CHURCH ST. PHASES 2 & 3

SUMMARY

<p>Owner Church Street Phase II LLC</p> <p>Applicant Meghan Dietz</p> <p>Project Planner Chris DeLoatche</p> <p>Updated: October 7, 2019</p>	<p>Property Location: 333 & 225 S. Garland Ave., and 128 & 110 W. Church St. (Located south of W. Church St., north of W. South St. and east of S. Garland Ave) (+2.56 acres, District 5)</p> <p>Applicant's Request: A Master Plan amendment with modifications to the maximum allowed impervious surface ratio (ISR) and an intensity bonus of 5.0 floor area ratio (FAR) for the construction of a mixed-use high rise building adjacent to the Church St. Phase I tower currently under construction. The phased development plan includes:</p> <p>A. A 32-story, 400 ft. mixed-use high rise development with 209 hotel units, 19 dwelling</p>	<p>units, +2,500 sq. ft. of ground floor retail, +59,500 sq. ft. of ballroom/hospitality, +210,500 sq. ft. of office and an integrated 577 space parking garage (Phase 2).</p> <p>B. A +25,000 sq. ft. addition of commercial space to 128 W. Church St. (Phase 3)</p> <p>Staff's Recommendation: Approval of the request, subject to the conditions in this report.</p> <p>Public Comment: Courtesy notices

ISR CALCULATIONS

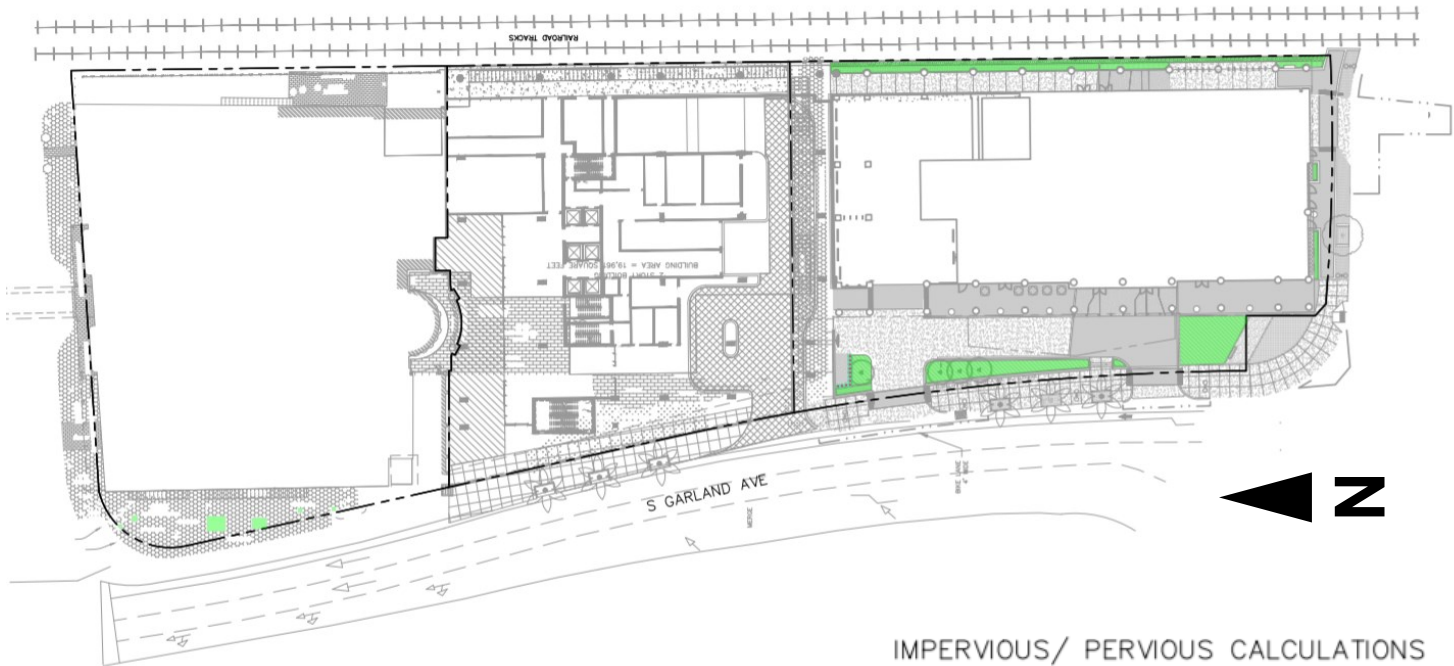
The applicant is also proposing a modification of standards to the Master Plan as part of the request. The development site is limited to 0.95 or 95% impervious surface ratio where the applicant is proposing 97.76% ISR. Through a Master Plan with modifications the maximum permitted ISR may be increased by up to 20% of the numerical standard. The proposed 2.76% increase is under the allowed maximum of 20%. Further development standards can be found in Table 2 below.

LANDSCAPE PLAN

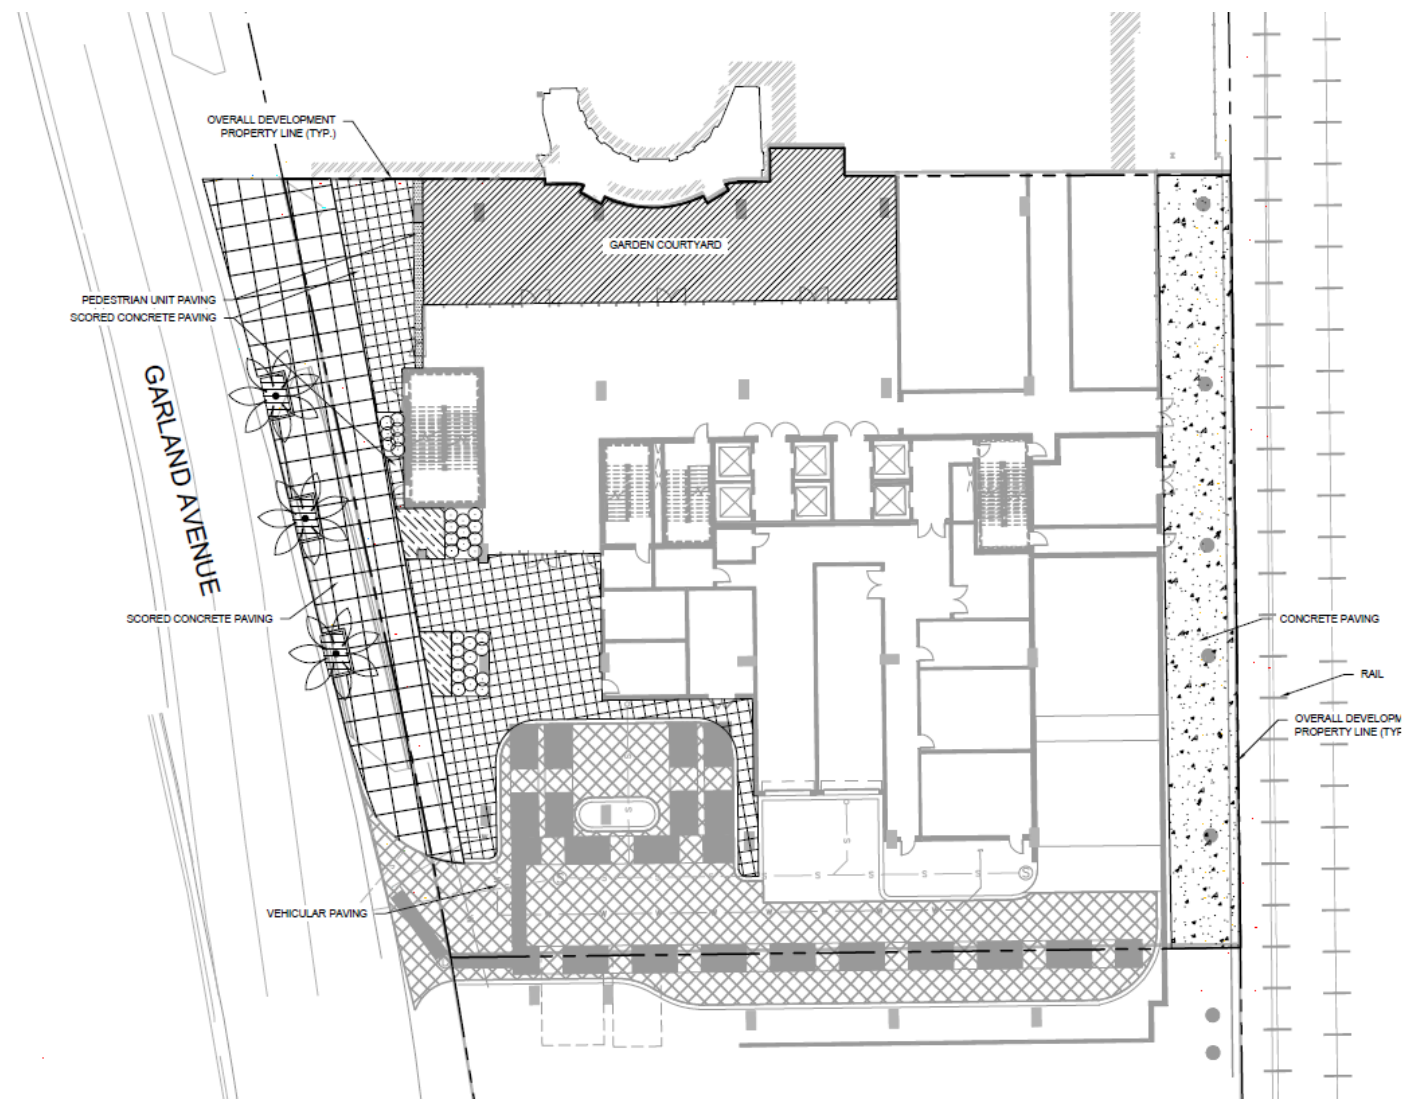
- a) Streetscape (met). The project provides the required streetscape enhancement with a 15-ft section.
 - b) Landscaping (partially met). The project will need to provide landscaping points 10% over typical code requirements. The project as presented has the potential to provide plantings on balconies, roofs, and the “porch” area at the entry to the building that will need to be reviewed for compliance with this requirement.

2. All other comments and conditions as required by the HPB under the Major Certificate of Appropriateness.
3. The project will need to provide landscaping points 10% over typical code requirements. The project as presented has the potential to provide plantings on balconies, roofs, and the "porch" area at the entry to the building that will need to be reviewed for compliance with this requirement.

EAST ELEVATIONS

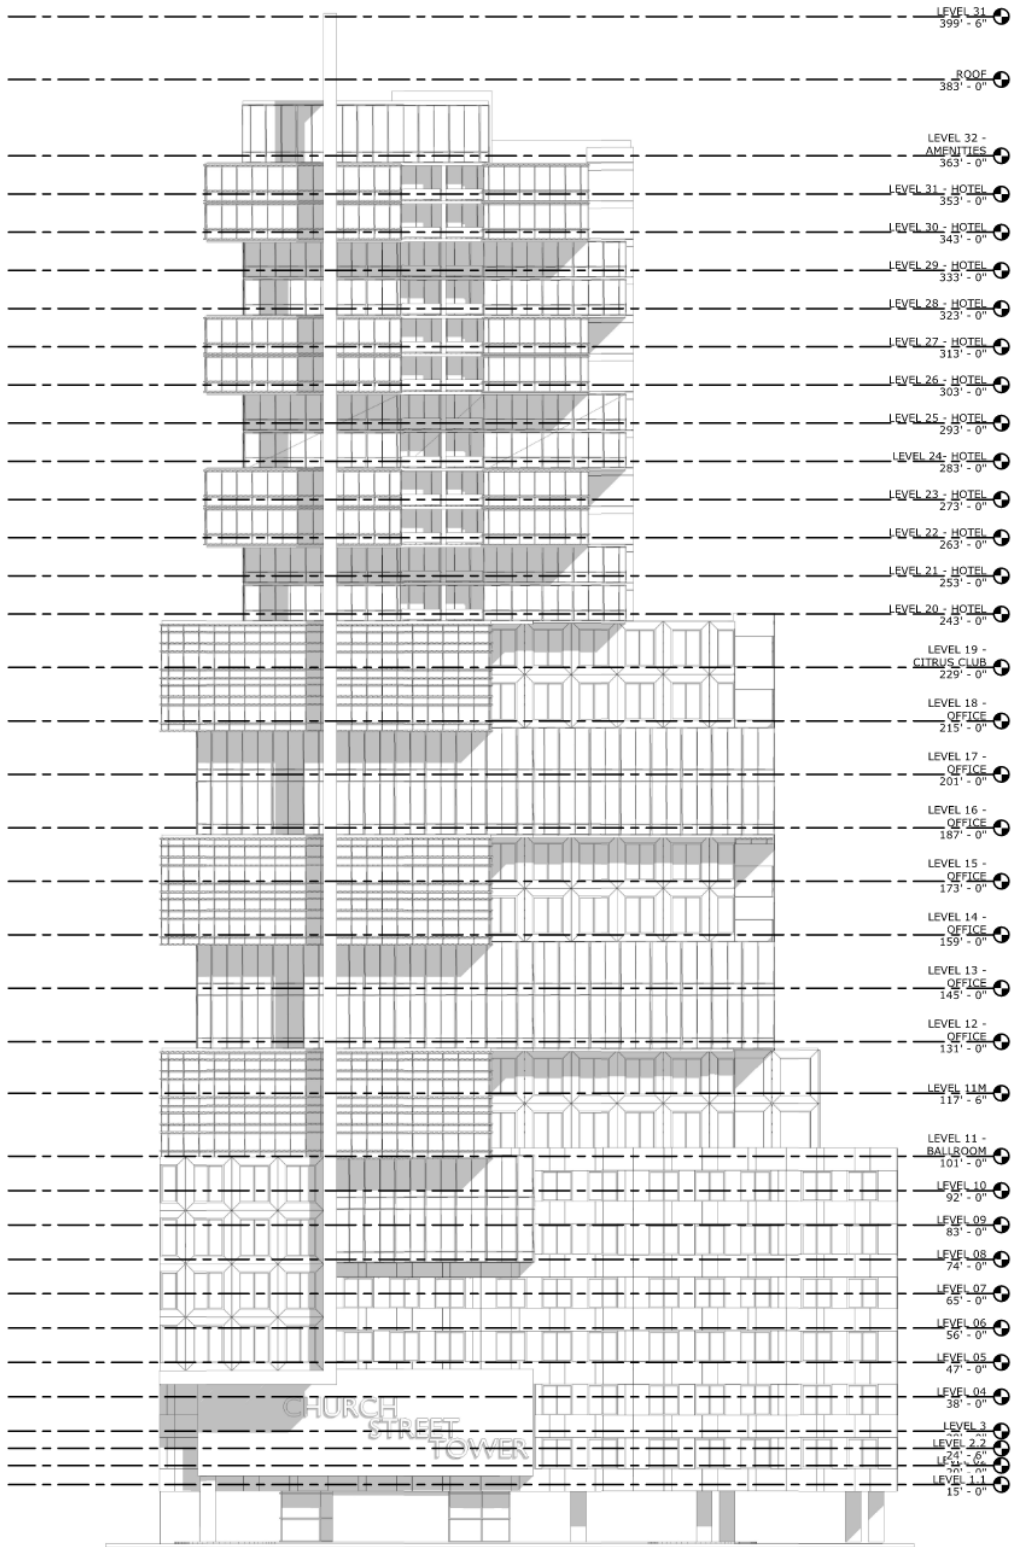
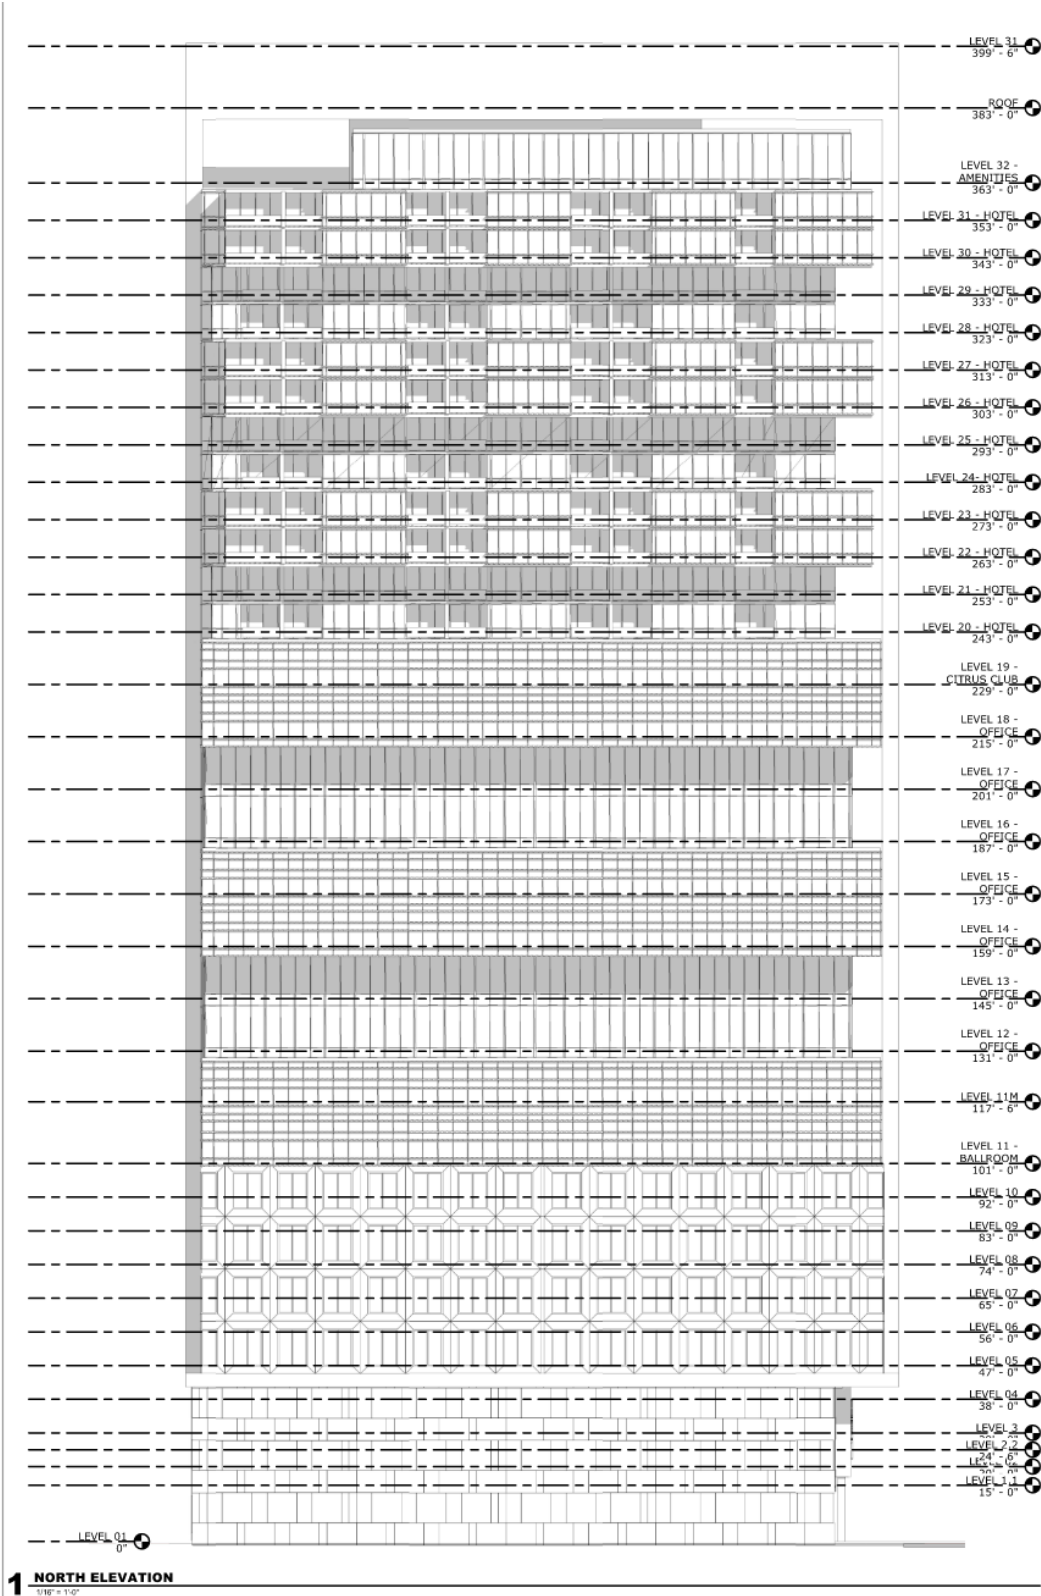
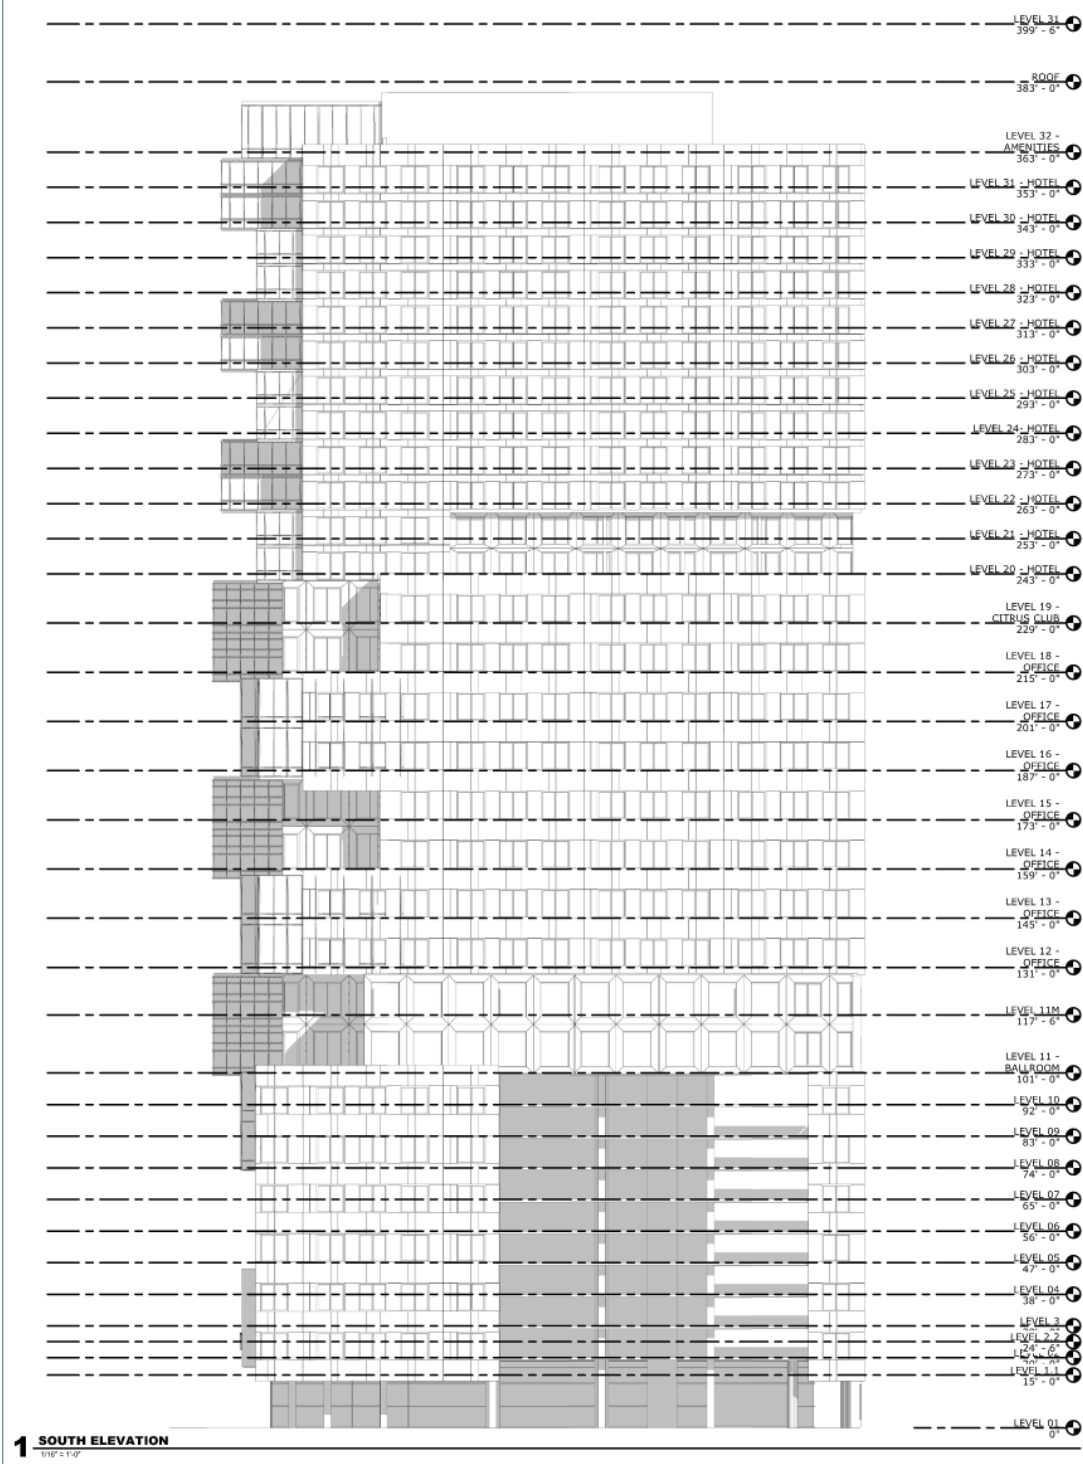
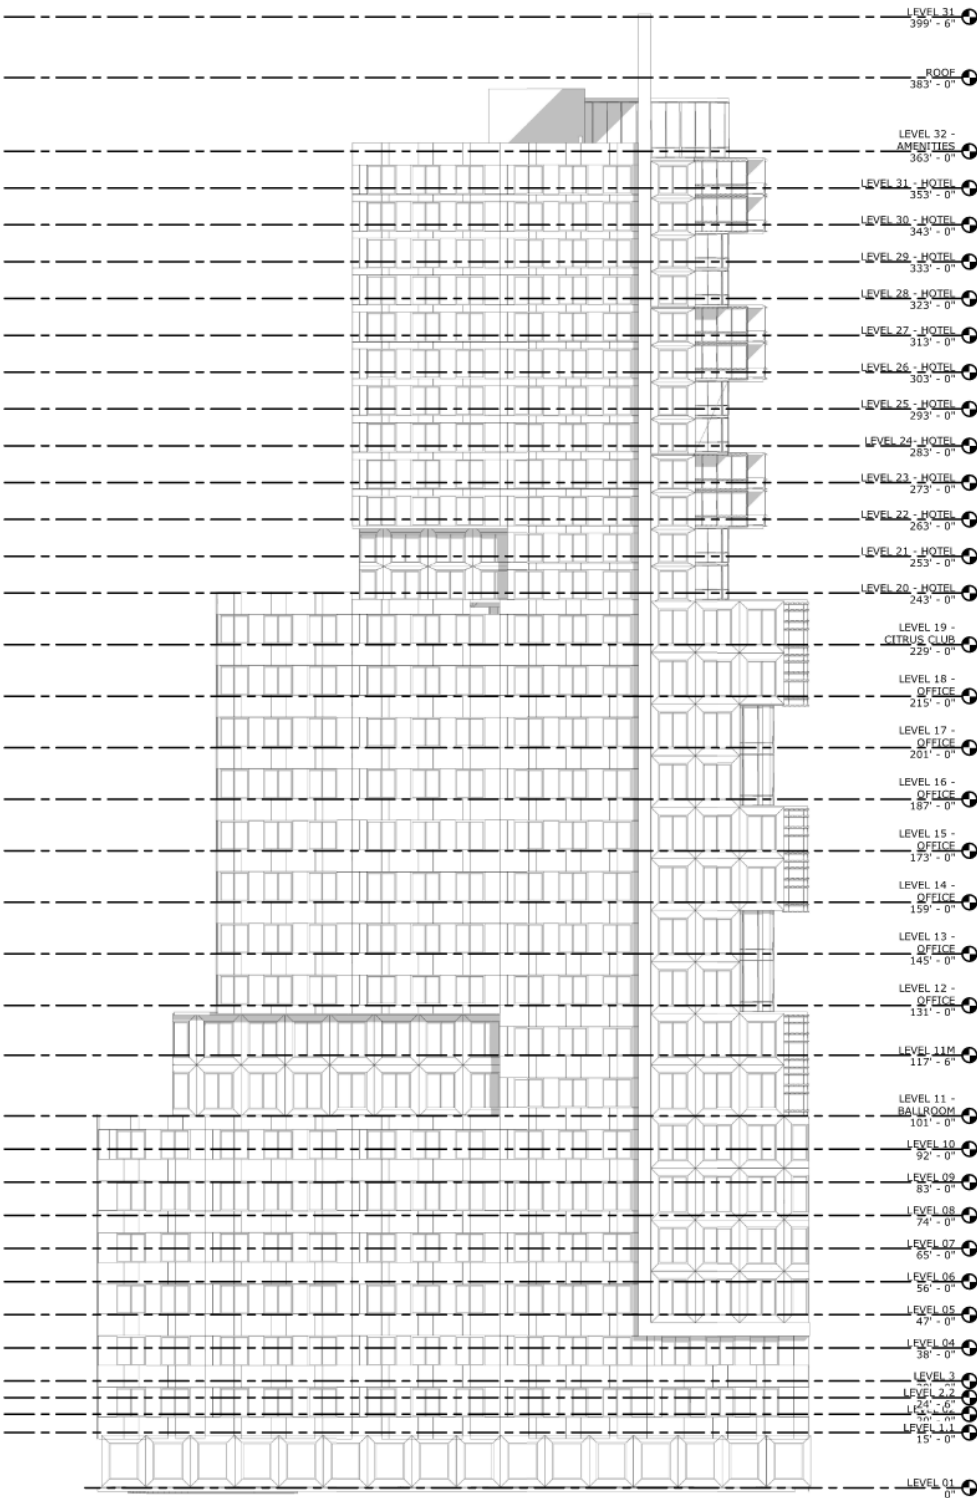
17. Separate demo permits is required for each structure on the site.
 1. It is recommended that a non-reflected material be used on the Western elevation of the building tower, in order to minimize glare/reflection onto the new elevated Interstate 400 (I-4).
